BARBUR BOULEVARD ROAD SAFETY AUDIT

SW Capitol Highway to SW Naito Parkway

October 2015

Road Safety Audit Report

Exhibit 15. Suggested Cross-section

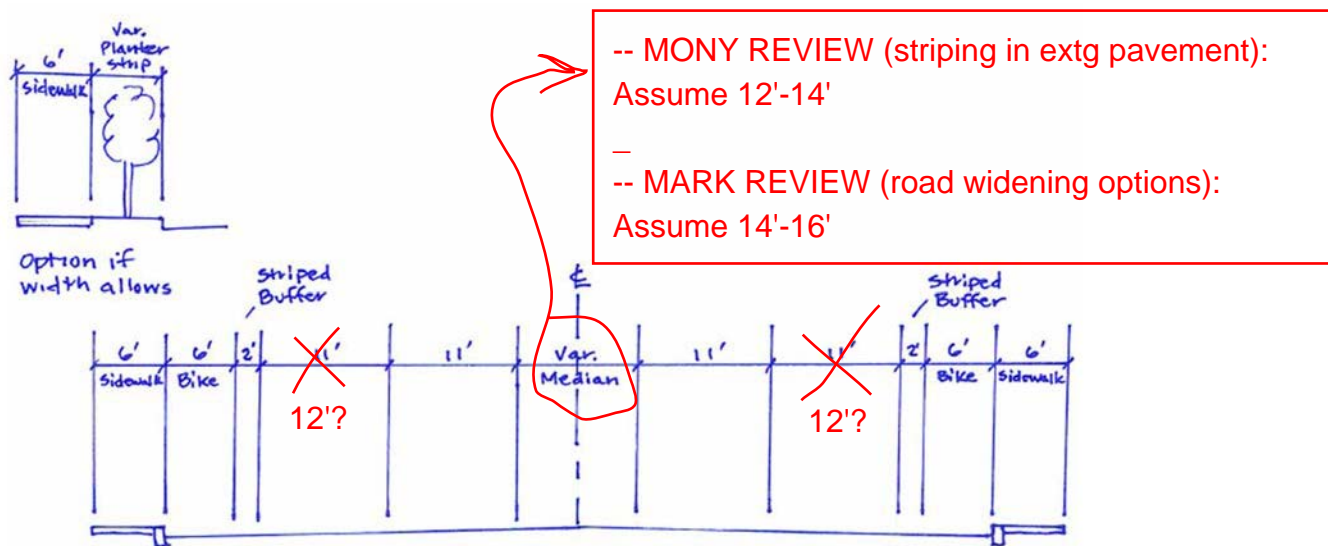
- Narrow travel lanes (12 feet to 11 feet) to provide the opportunity for buffered bicycle lanes where feasible, per suggested cross-section in Exhibit 15. It is understood that this cross-section may not be able to be implemented throughout the entire study corridor in the near- to intermediate-term due to physical constraints such as the Newbury, Vermont, and Multnomah (at Safeway) Bridges, as well as the embankment section just north of the SW Capitol Hill Road-SW 19th Avenue intersection.

Exhibit 30. Existing intersection configuration and key characteristics of Barbur Boulevard/SW Capitol Highway

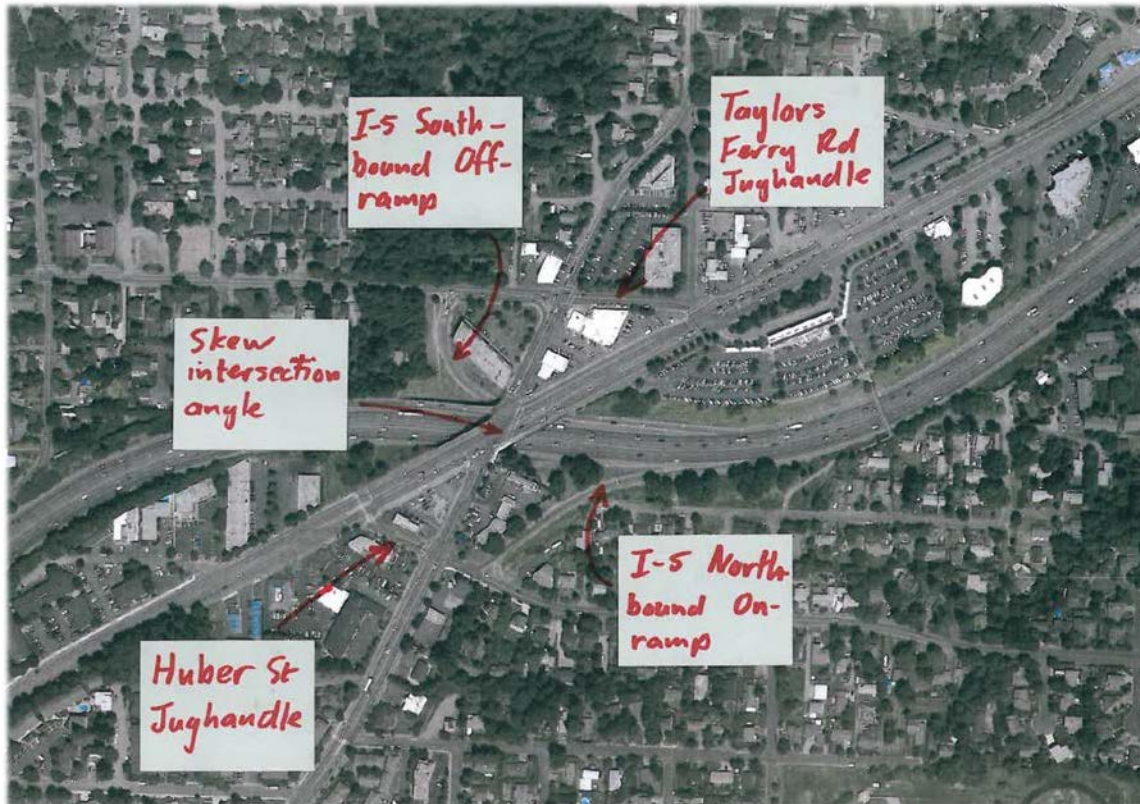
- Skewed intersection angle between Barbur Boulevard and SW Capitol Highway.
- SW Huber Street and SW Taylors Ferry Road jughandles accommodate left-turns from Barbur Boulevard and SW Capitol Highway. The existing signage does not clearly define the desired travel paths for these left-turns through the jughandle configurations.
- Southbound I-5 off-ramp is located on a lower road hierarchy (SW Taylors Ferry Road) compared to Barbur Boulevard and SW Capitol Highway.
- Northbound I-5 on-ramp is located on a lower road hierarchy (SW Huber Street) compared to Barbur Boulevard and SW Capitol Highway.
- The intersection is complex due to the skewed alignment and the I-5 southbound on-ramp, as seen in Exhibit 31.

Exhibit 34. Suggested paths for left-turns off Barbur Boulevard through jughandles

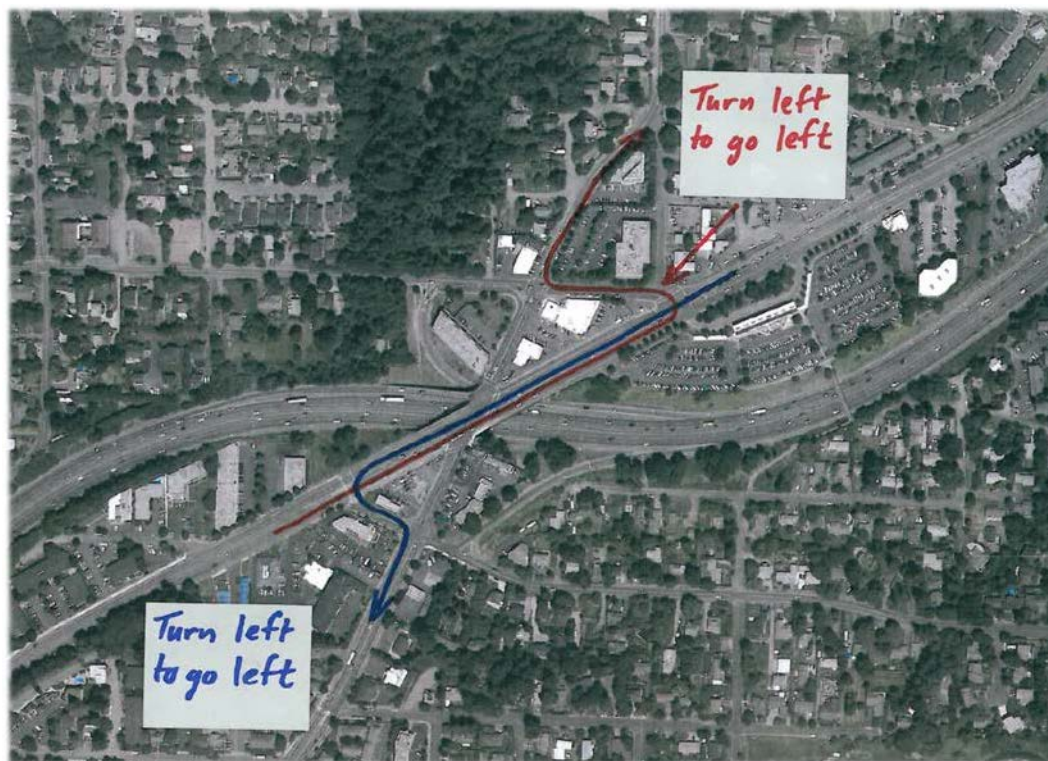
- Install retro-reflective backplates and supplemental signal heads to address “disregarded traffic signal” related crashes.
- Revisit signal head orientation and/or installing programmable signal heads to address acute angle related crashes.
- Provide clear directional signage for SW Huber Street and SW Taylors Ferry Road jughandles, directing vehicles to continue through the intersection and make a downstream left (since left-turns are not allowed at the intersection) (See Exhibit 34). This suggestion needs to be analyzed to understand the potential impacts on the key intersections within the jughandle configurations.

Exhibit 36. Relocate existing lefts

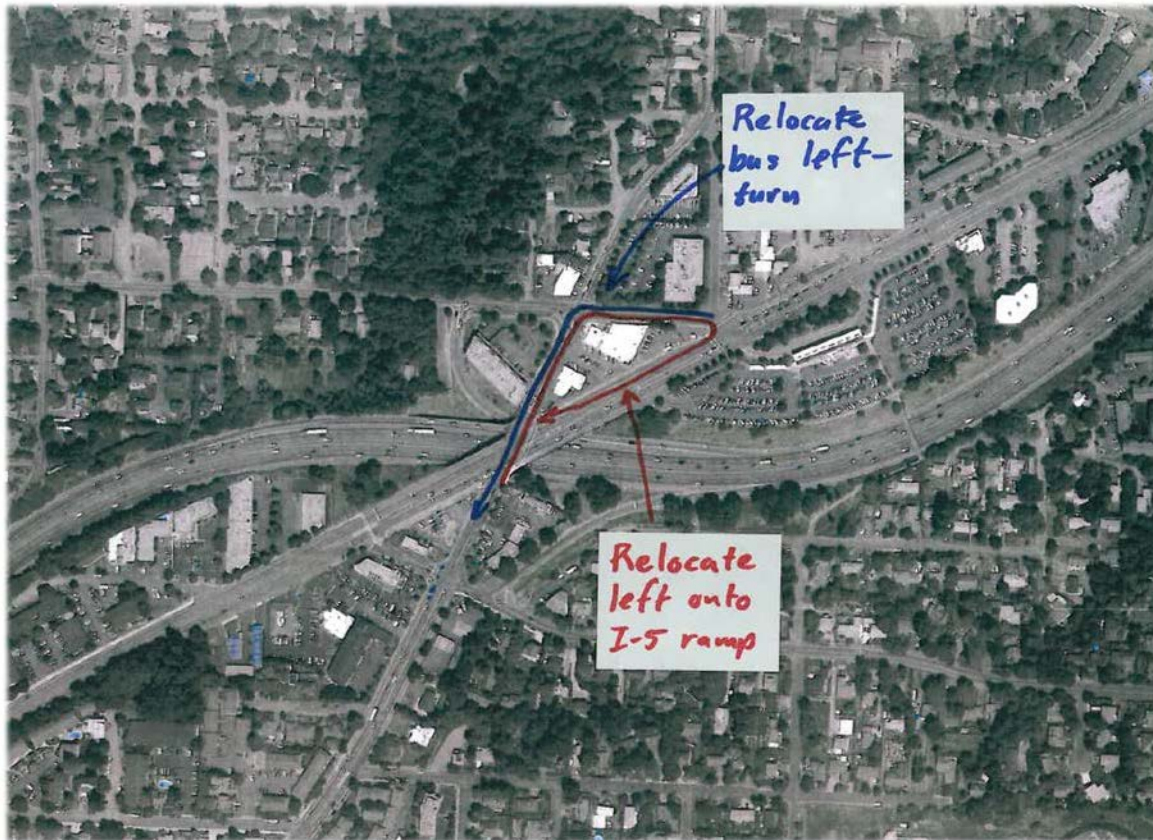
- Remove all left-turns at main intersection, as shown in Exhibit 36.

Exhibit 37. Relocate I-5 Southbound On-Ramp

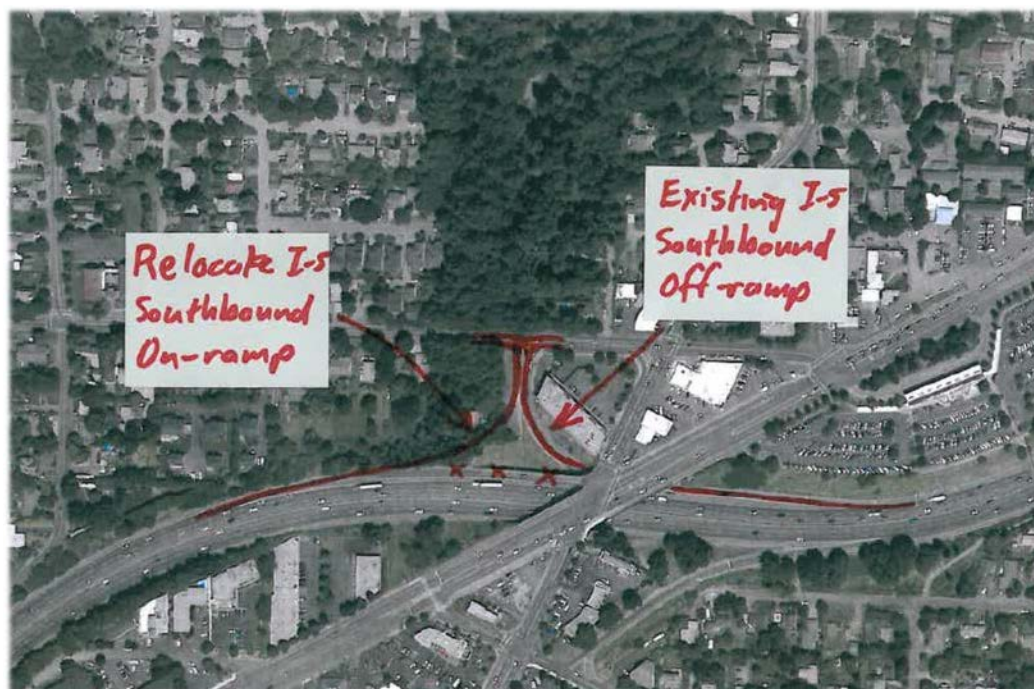
- Improve the existing SW Taylors Ferry Road/SW Capitol Highway intersection with a signal or single-lane roundabout, maintaining a channelized eastbound right-turn.
- Consider options for better traffic control and improve the jughandles to provide separation of turning movements, such as:
 - Relocate I-5 southbound on-ramp to the existing I-5 southbound off-ramp/Taylors Ferry Road intersection (see Exhibit 37),
 - Develop two offset T-intersections of Capitol Highway with Barbur Boulevard (see Exhibit 38), or
 - Develop two offset T-intersections of Capitol Highway (east) and Taylors Ferry Road (west) with Barbur Boulevard (see Exhibit 39).
- Consider an intersection/interchange preliminary design study to identify future needs at this location and identify property impacts.

Exhibit 55. Cross-section options for Bridge over SW Multnomah Boulevard

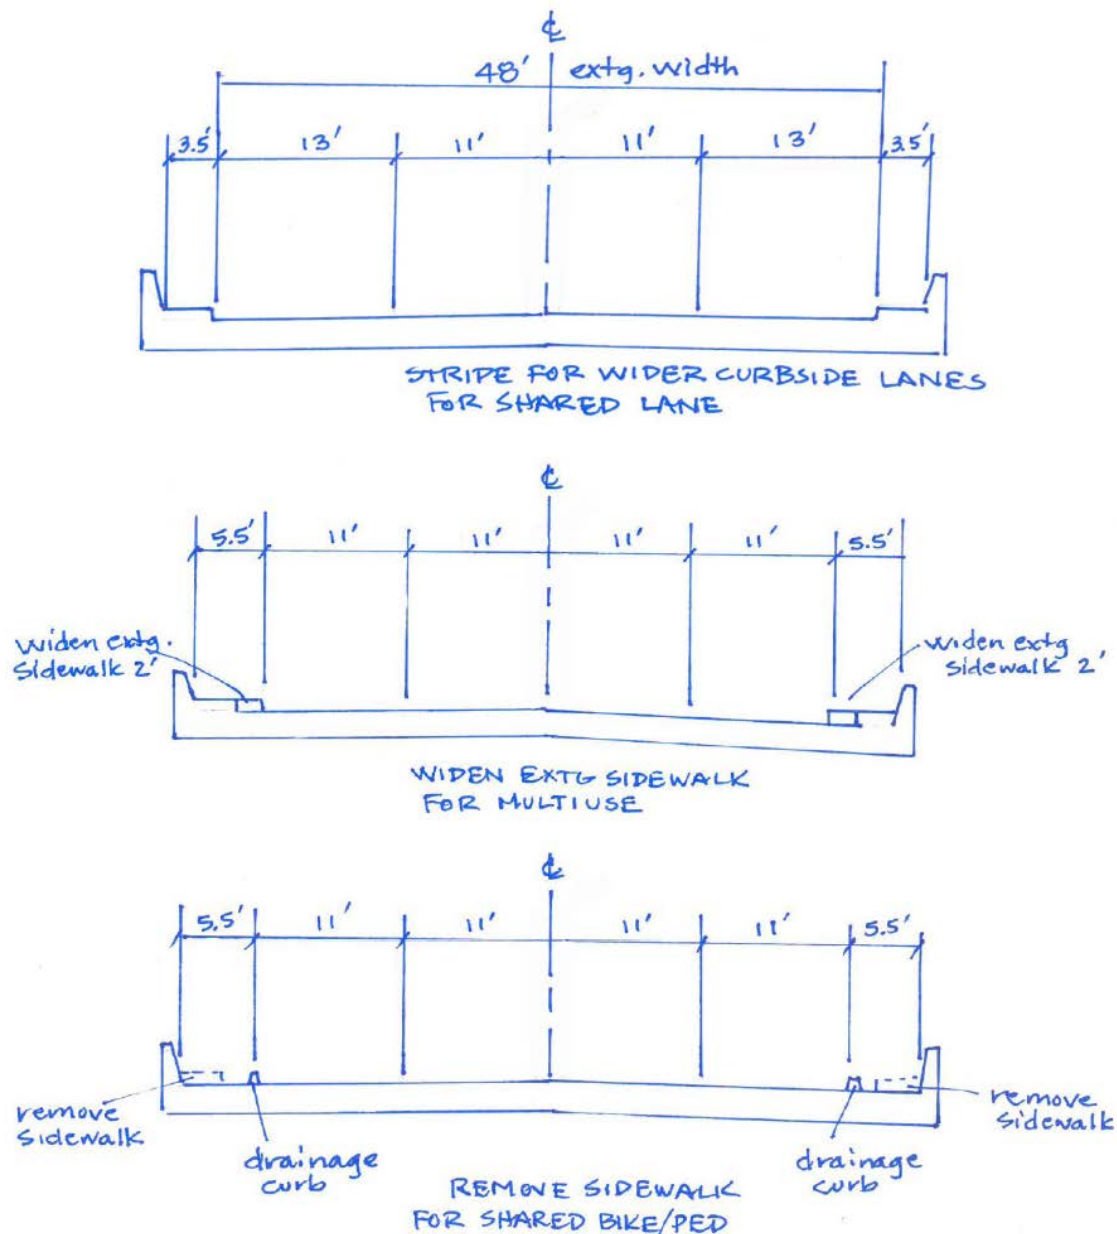
- Combine SW 22nd Avenue and SW Spring Garden Street on the east side of the intersection by T-ing them into a single intersection (this would entail right-of-way impacts).
- Explore opportunities to realign sidestreet to intersect with Barbur Boulevard more perpendicular.
- Consider options for the bridge that narrow the travel lanes to provide improved shared bicycle and pedestrian facilities, as shown in Exhibit 55. These options need to be evaluated to determine how the cross-section on the bridge would transition to/from the adjacent approaching road segments.

Exhibit 62. Options for Roadway Cross-section on Embankment

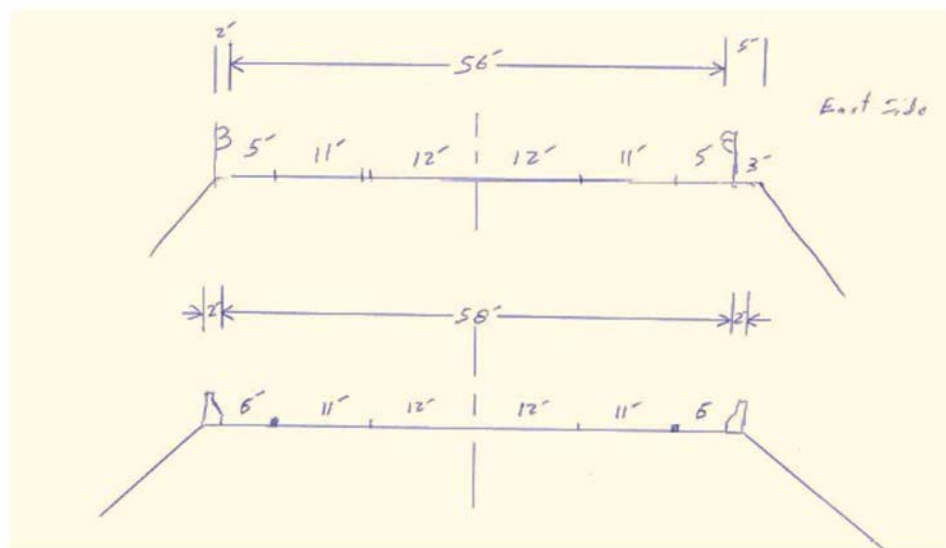
- Infill sidewalk gaps on the east side of the roadway and address ADA issues.
- Implement access management strategies as part of redevelopment.
- Consider modifying the cross-section over the embankment to either restripe within the existing guardrails or widen onto the existing road prism with a barrier, as shown in Exhibit 62.

Exhibit 80. Option #2 cross-section with 10-foot travel lanes and bicycle lanes

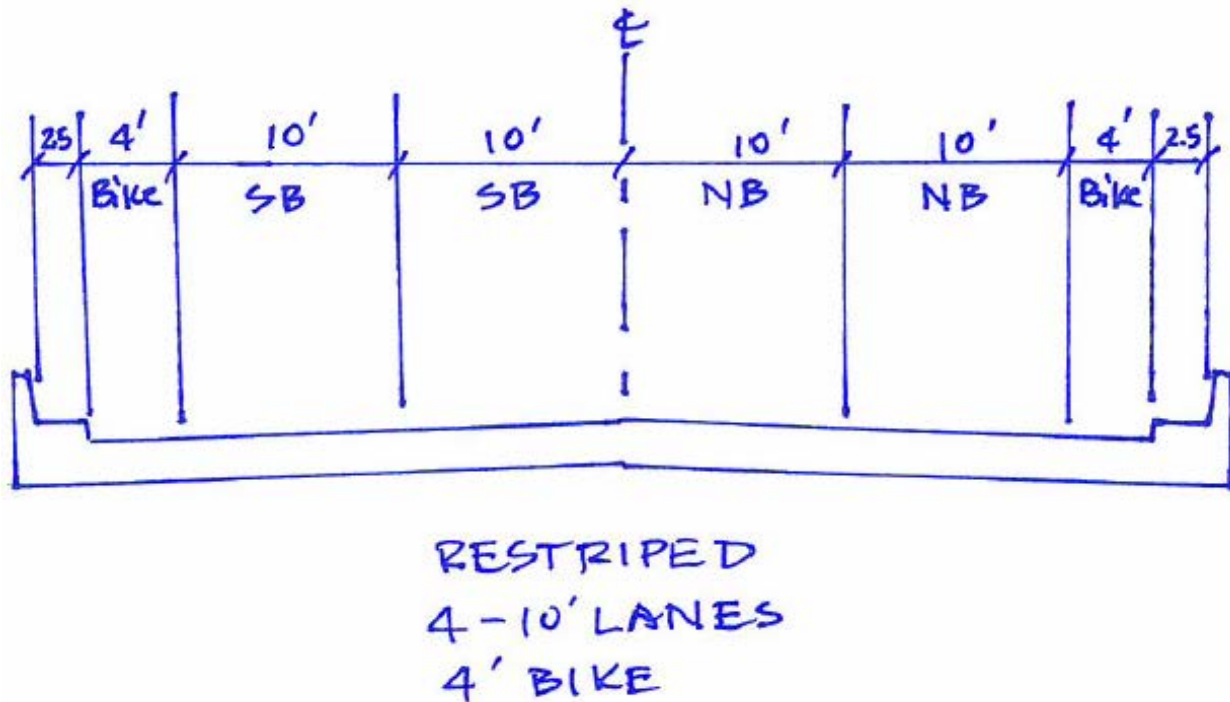
This option modifies the existing cross-section on the bridge by restriping within the existing pavement width to introduce 4-foot bicycle lanes or shoulder in addition to the existing four narrower travel lanes, as shown in Exhibit 80. The evaluation of this option illustrates the challenges with reallocating space on the bridges to provide bicycle lanes within the existing cross-section. The RSA Team discussed the challenges with this exploration, if the character of the road does not change to encourage slower speeds through this segment, and noted that other options for providing bicycle facilities are more desirable for both vehicle and bicycle comfort and safety, such as providing a three-lane cross-section (see Options #4, #5, and #6), as well as wider sidewalks (Option #3).

Exhibit 81. Option #3 cross-section with 11-foot travel lanes and wider sidewalks

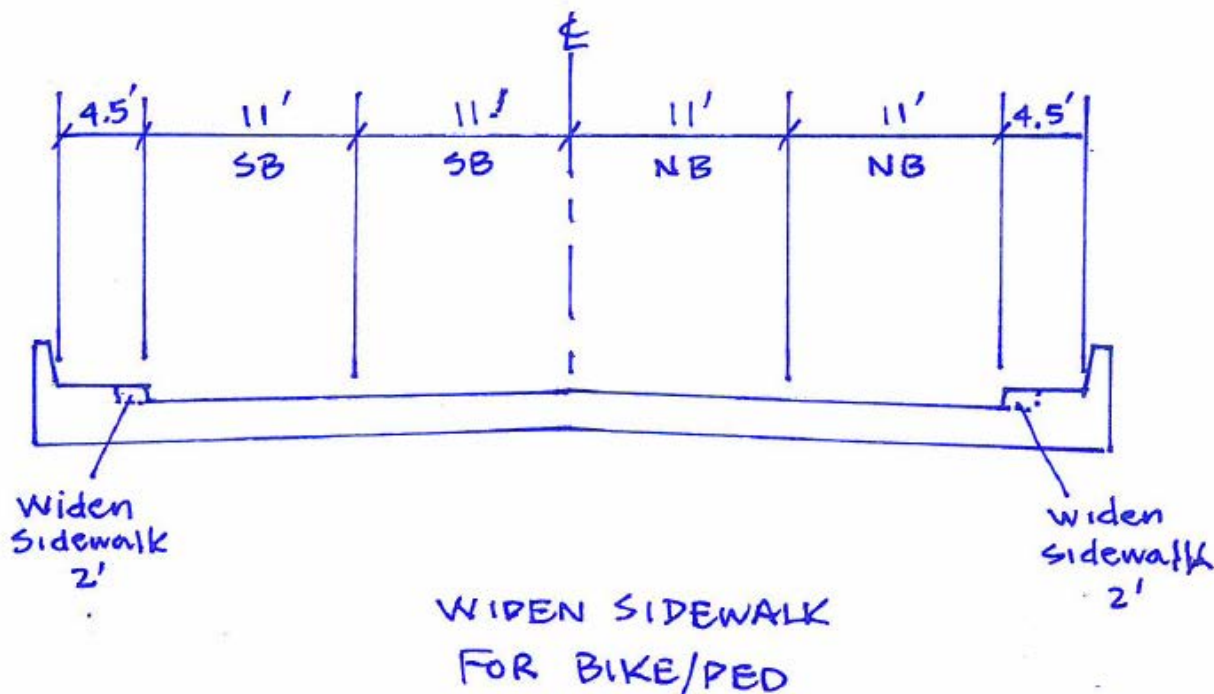
This option keep existing beacons and widens the existing sidewalks to 4.5 feet while maintaining four 11-foot travel lanes on the bridge, as shown in Exhibit 81. The 4.5-foot raised sidewalk serves both pedestrians and bicycles. The evaluation of this option illustrates the challenges and opportunities with creating shared space to accommodate bicycles and pedestrians within the existing cross-section.

Exhibit 82. Option #4 cross-section with three-travel lanes and buffered bicycle lanes

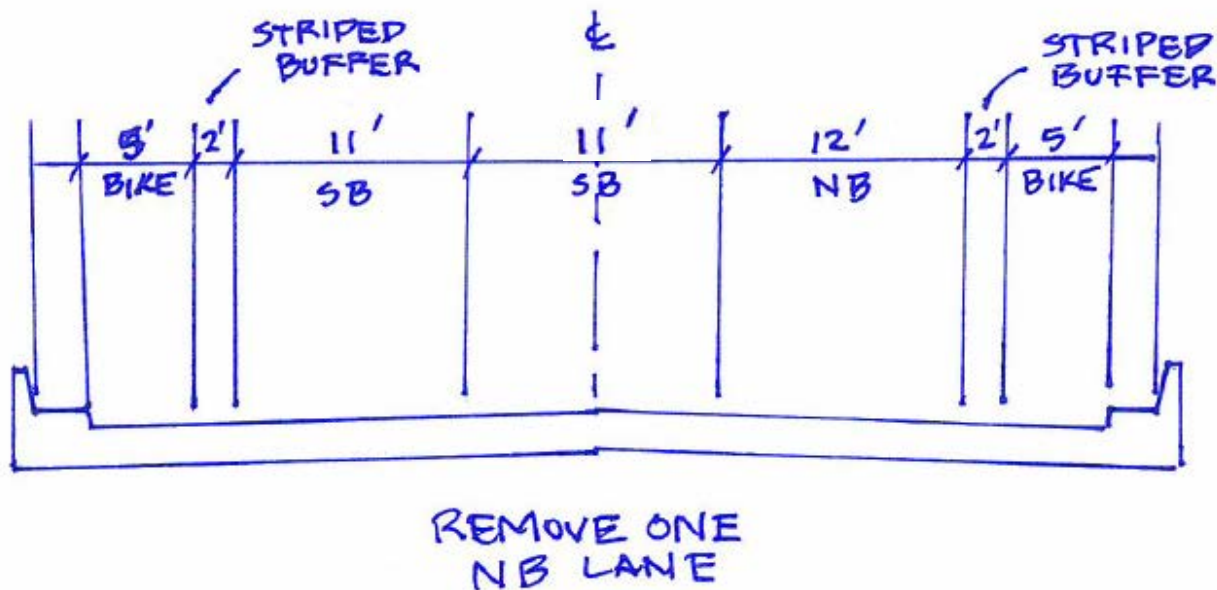
This option modifies the existing cross-section by restriping within the existing pavement width to introduce buffered bicycle lanes and to reduce the number of lanes on the bridges to three travel lanes, as shown in Exhibit 82. Removing the fourth lane is accomplished by merging one of the northbound through lanes prior to the most southern bridge.

- Buffered bicycle lanes provide additional protection and have demonstrated safety improvements over a typical bicycle lane.
- Speed management in the northbound direction created through the required merge before the bridges and single travel lane.
- Horizontal separation between bicycles and auto traffic provided.

Exhibit 83. Option #5 cross-section with three-travel lanes and buffered bicycle lanes

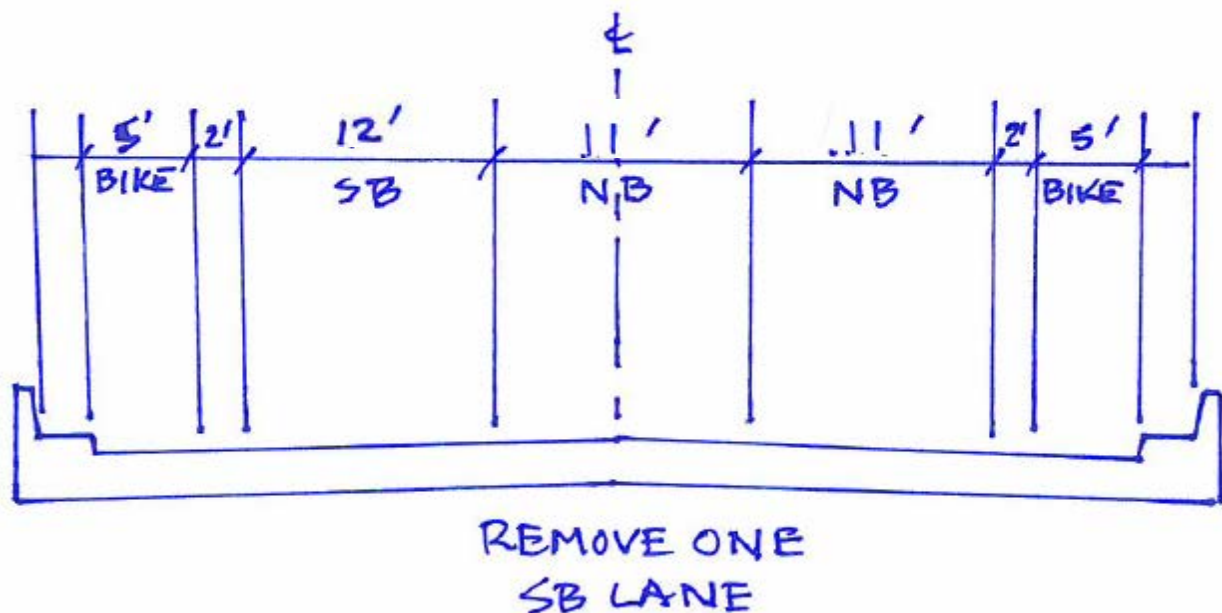
This option modifies the existing cross-section by restriping within the existing pavement width to introduce buffered bicycle lanes and to reduce the number of lanes on the bridge to three travel lanes, as shown in Exhibit 83. Removal of the fourth lane is accomplished by dropping the southbound outside lane into a right-turn only lane onto Capitol Highway. Based on recent 2-hour peak period traffic counts (April 2014), it appears the split between southbound Barbur/Capitol traffic is approximately between 50/50 and 60/40:

This traffic volume split supports the suggested right-turn lane channelization. This option will likely need overhead signage to clearly show the outside southbound drop lane.
